Rotax TaG Jet Kit Update 12/2008

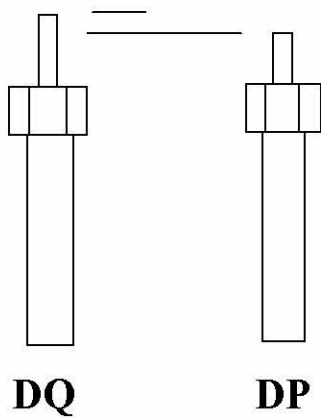
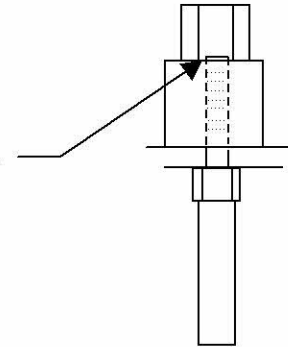
GFK is supplying new TaG kits with the DP266 atomizer rather than the original DQ266. The difference in the DP266 is the nozzle portion of the atomizer is approximately 1mm shorter than the DQ266 atomizer nozzle.

This change allows the atomizer tip to align with the venturi nozzle in the same position as the original FN tip.

Note:
Teflon sealer tape can be applied to atomizer threads if leakage at nozzle joint is suspected.

Not required if joint is snug.
